ORIGINATION FORM

Proposed Revisions to a Standard Plans Index (Please provide all information — Incomplete forms will be returned)

Index Number: 676-010
Sheet Number (s): 4 of 4
Index Title: Cabinet Installation Details

EXISTING CONTROLLER CABINET

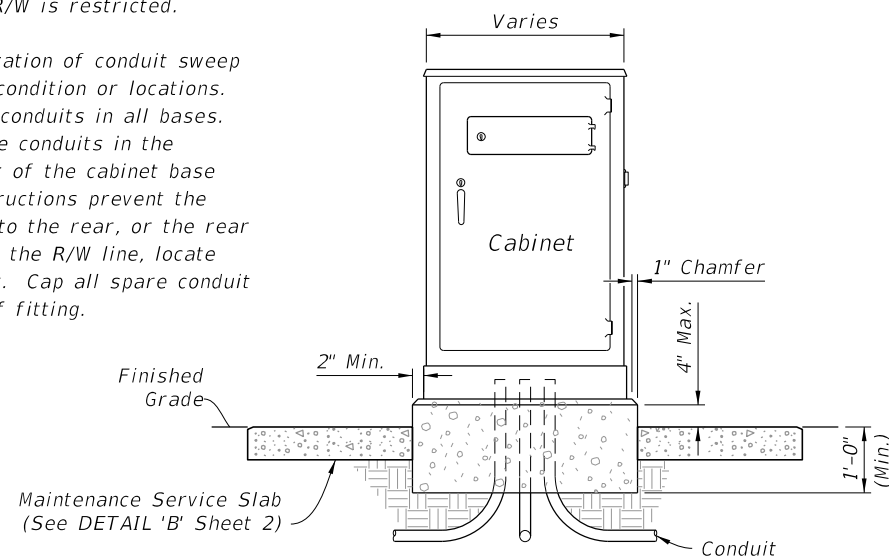
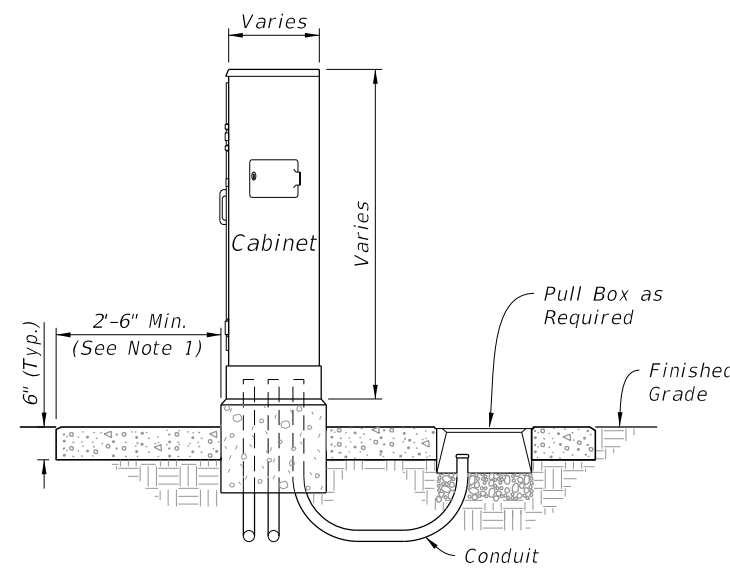
- Sheet 1: Deleted Existing Controller Cabinet elevation

The deletion of the Existing Controller Cabinet elevation and notes was requested by the TERL due to the requirements referenced in the notes being removed and the requirements for retrofitting cabinets varying based on agency needs. They also suggested we update the ITS cabinet on Sheet 2.

DELETED

GROUND MOUNTED INTELLIGENT TRANSPORTATION SYSTEMS (ITS) CABINET

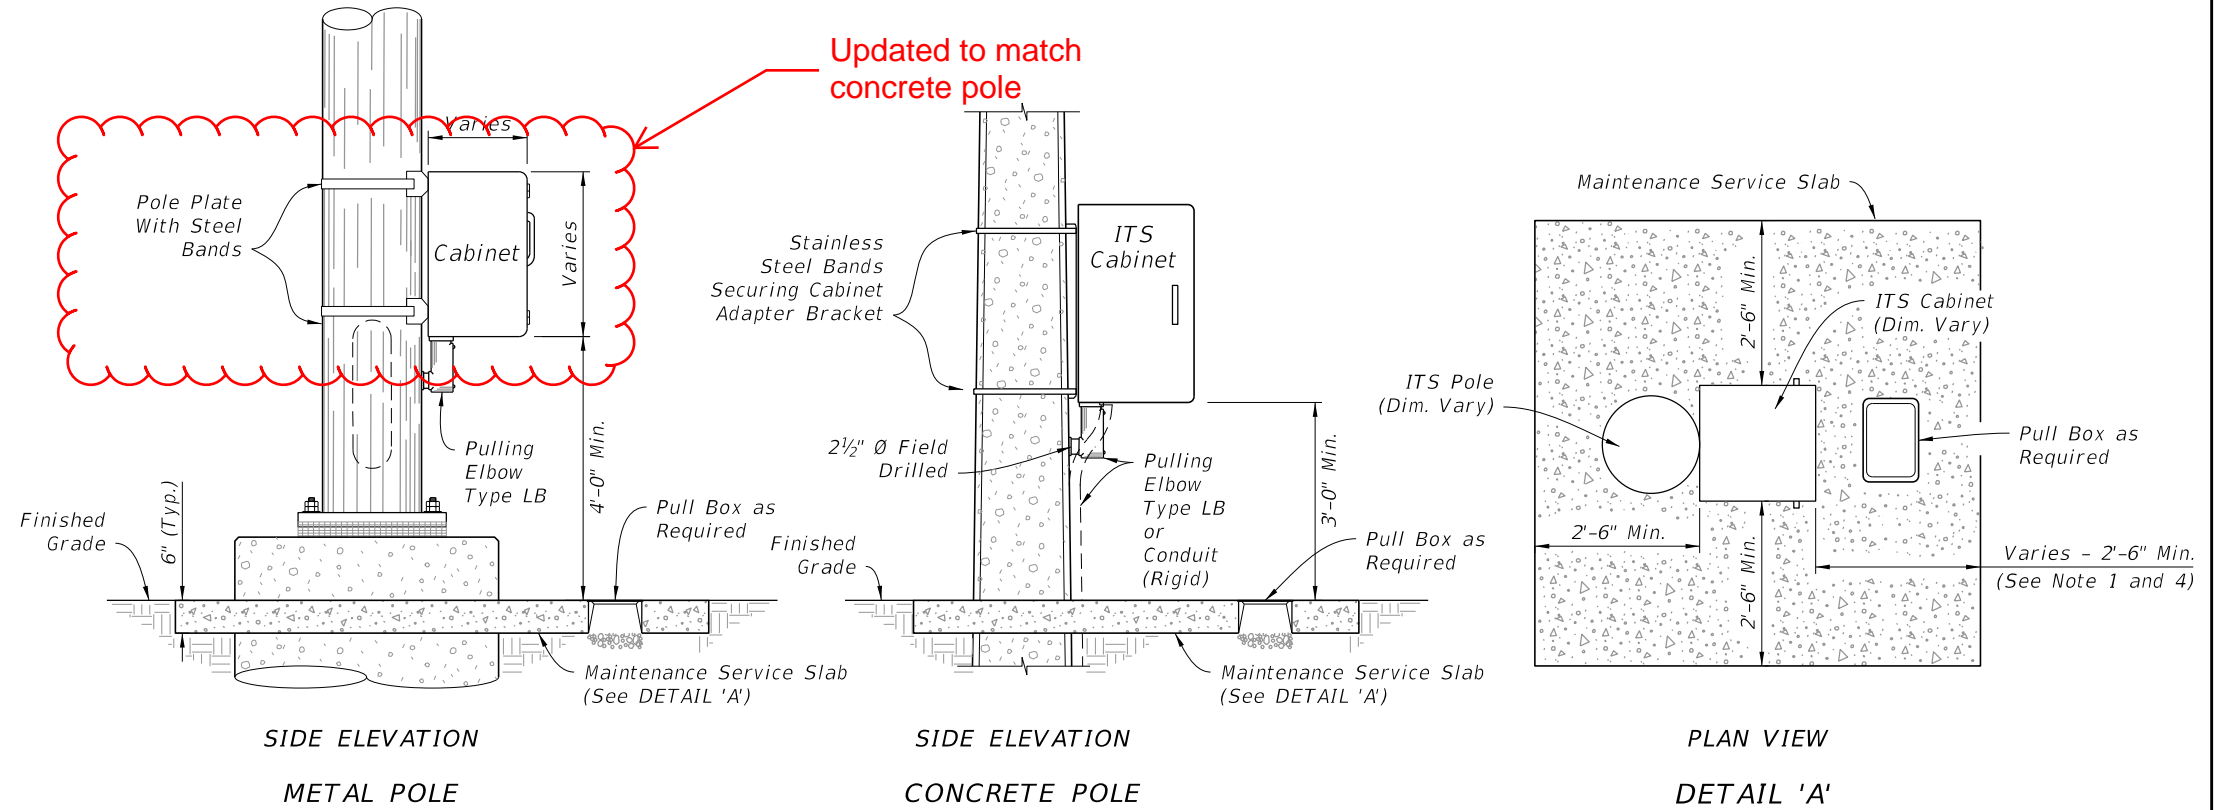
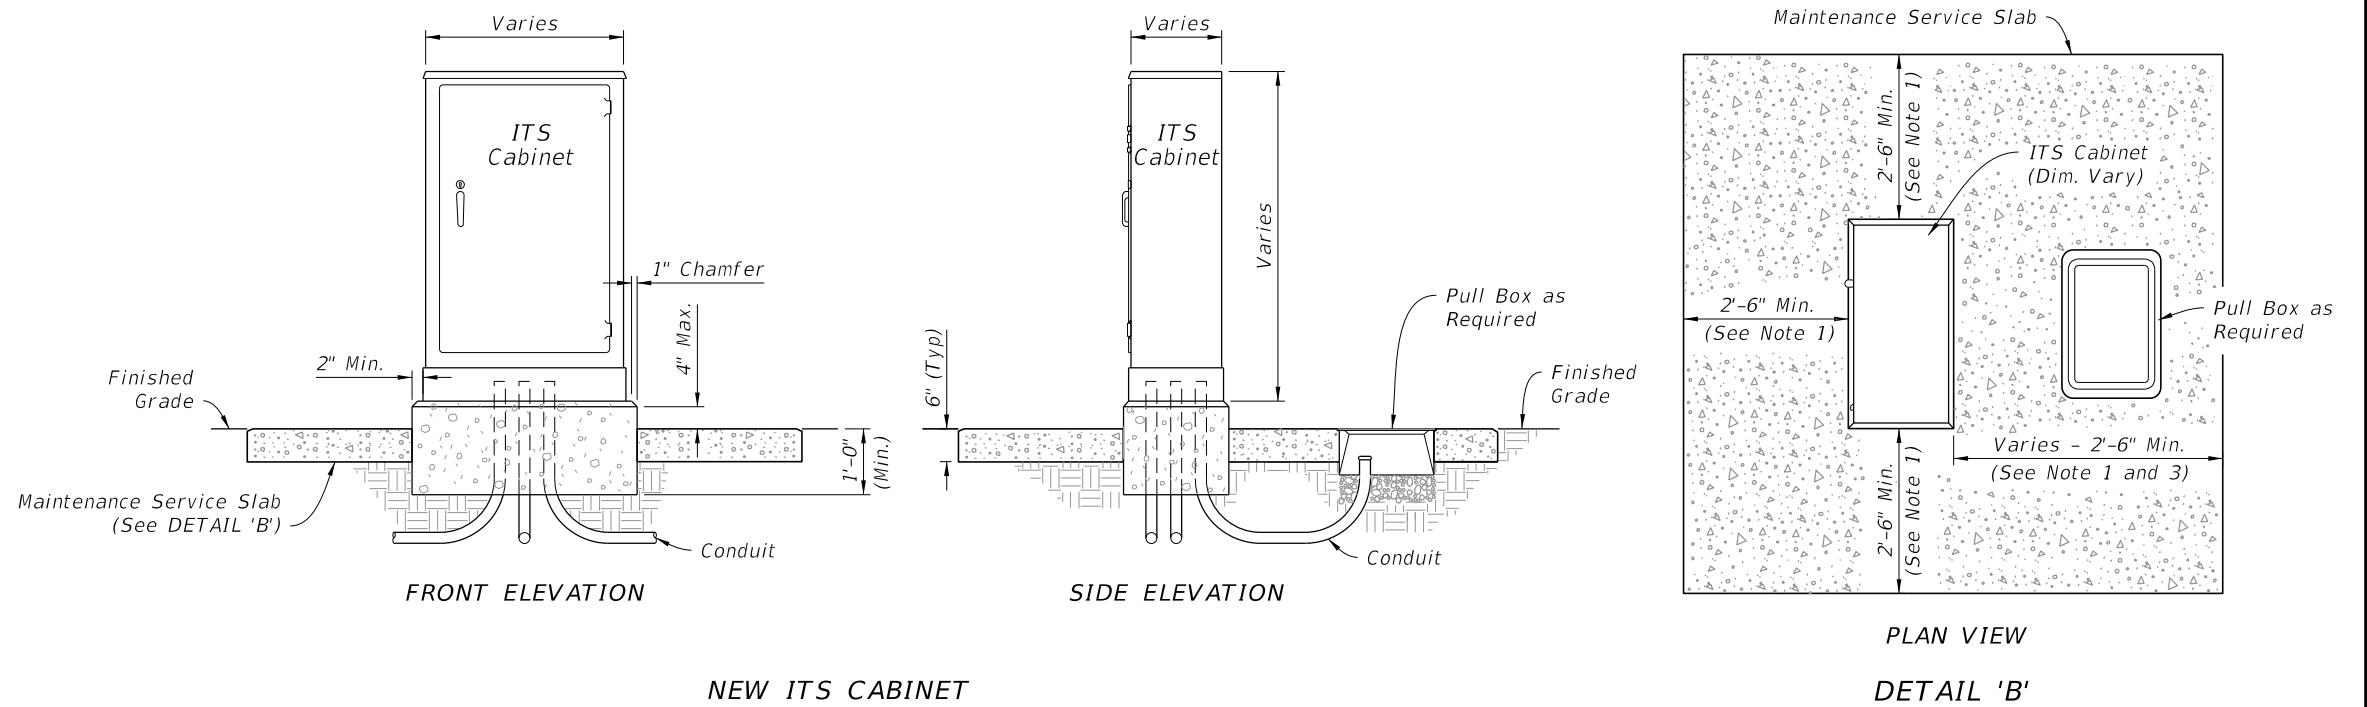
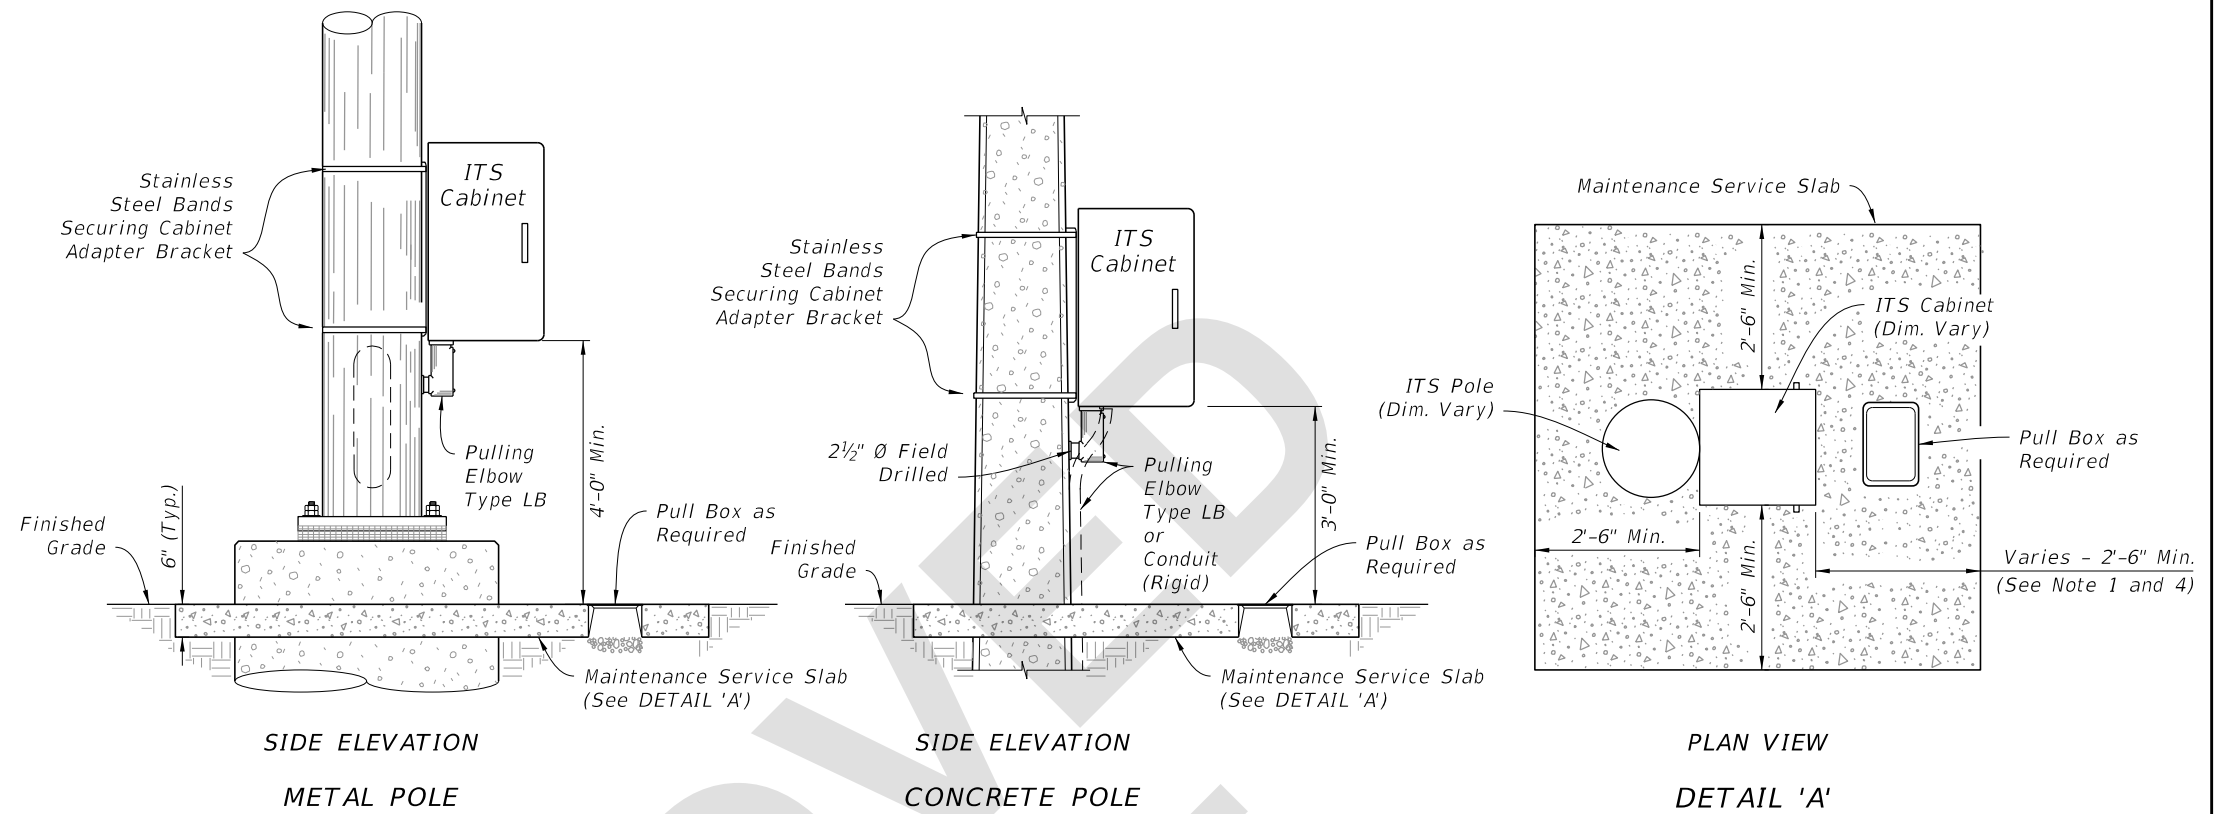
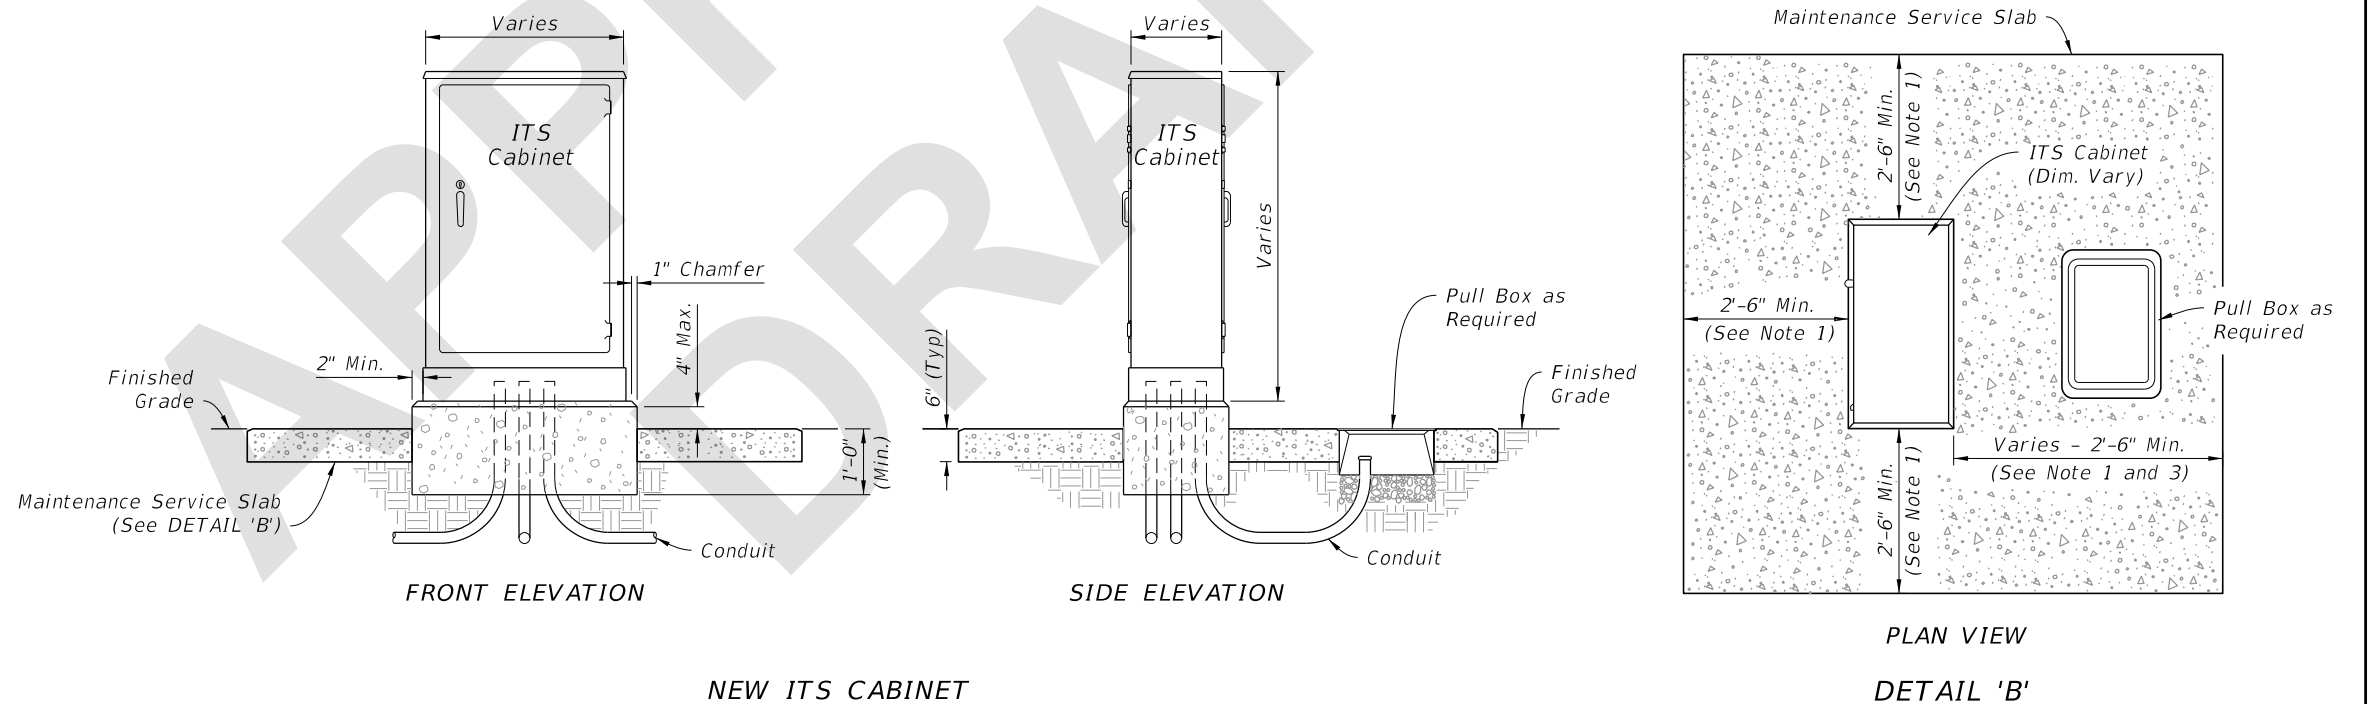
- Sheet 2: Updated Metal Pole cabinet to ITS cabinet

NEW ITS CABINET

GROUND MOUNTED CONTROLLER CABINET RISER

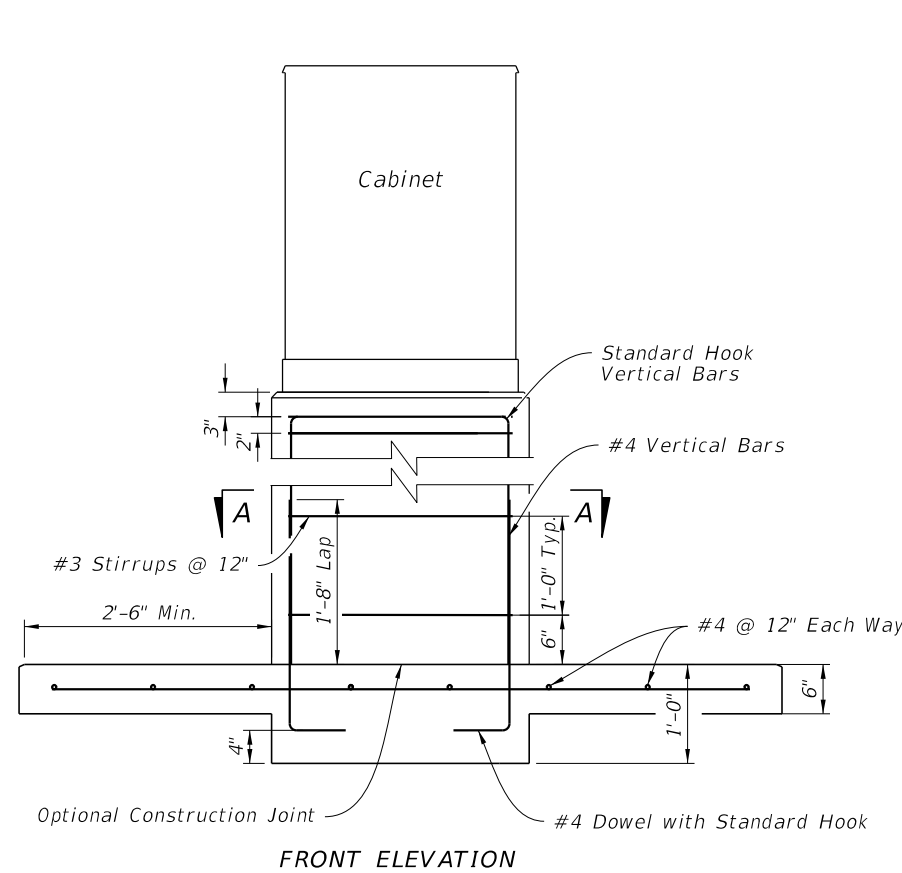
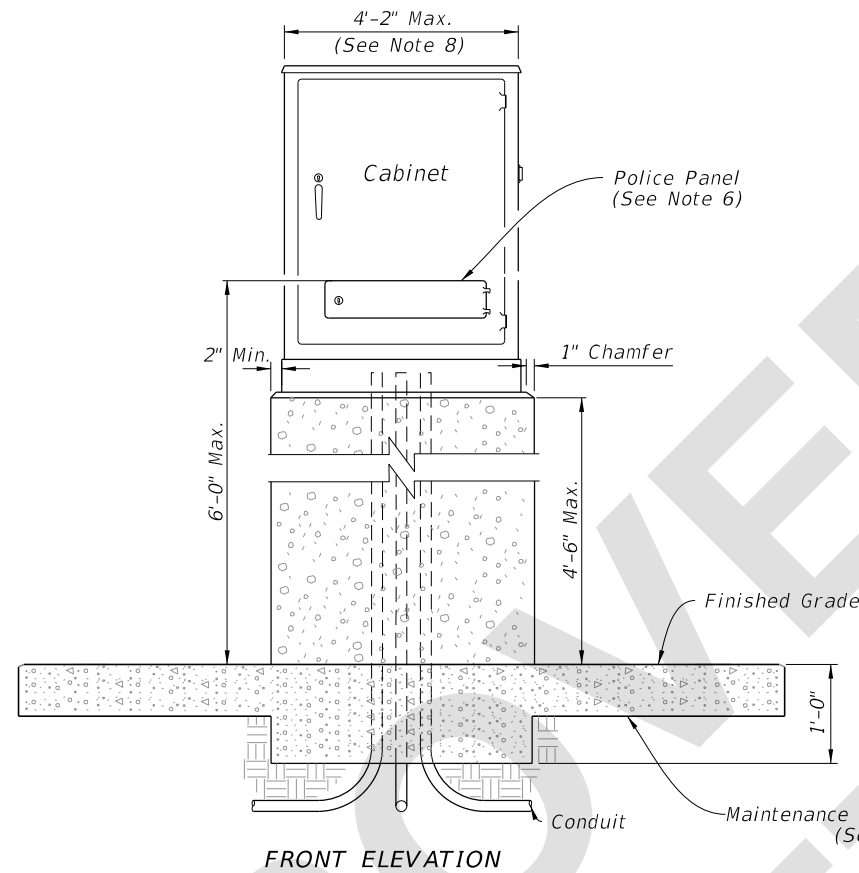
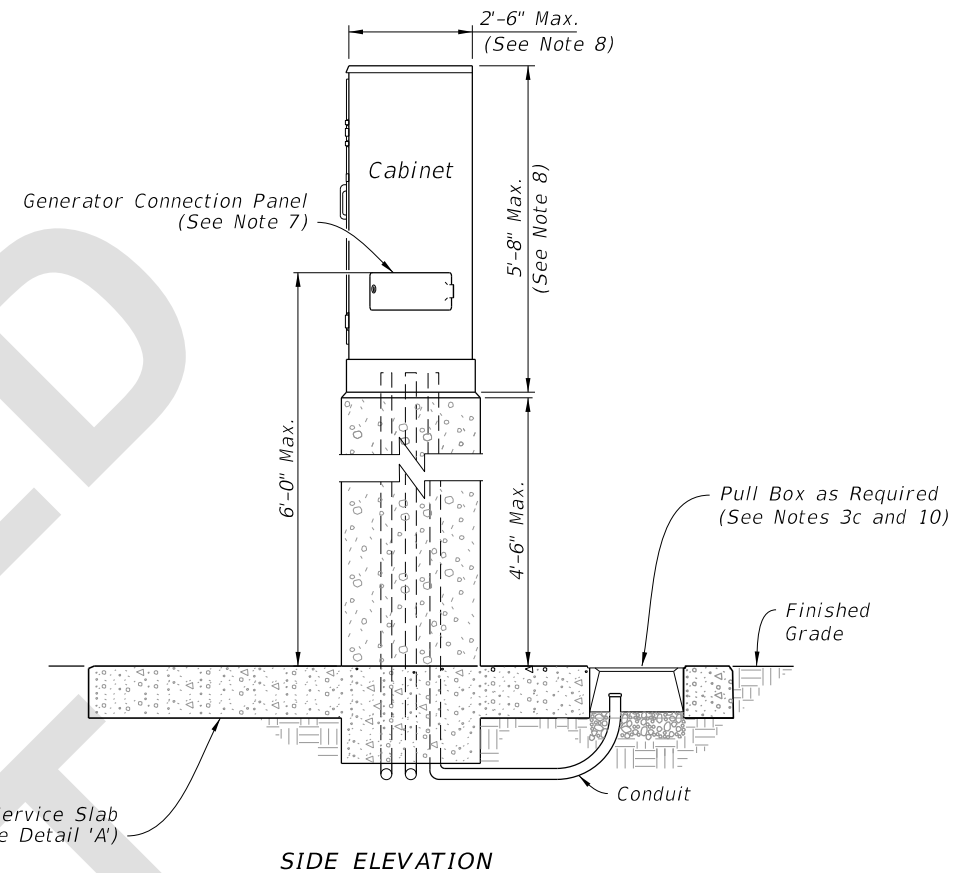
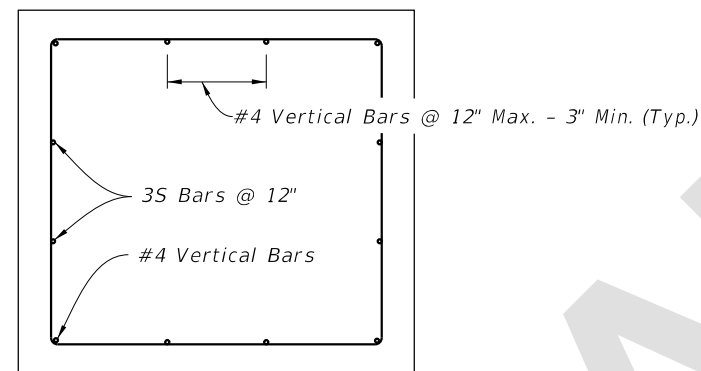
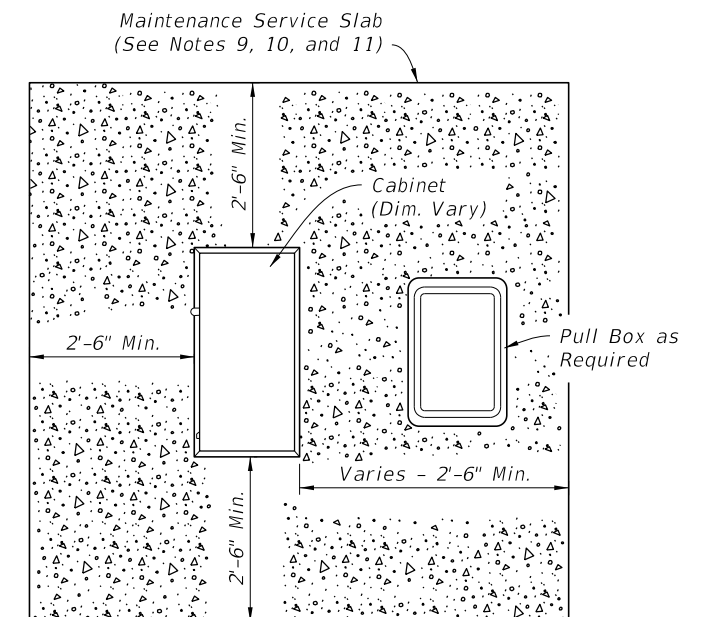
- Sheet 4: New Sheet for Ground Mounted Controller Cabinet Riser

This request came from the Districts and was coordinated with the TERL and Structures Design. Some Districts are installing these and the addition to the Standard Plans Index will allow use without a special detail in every plan set. This detail is for a concrete riser only. An associated change is being made to Specification 676 regarding this revision.
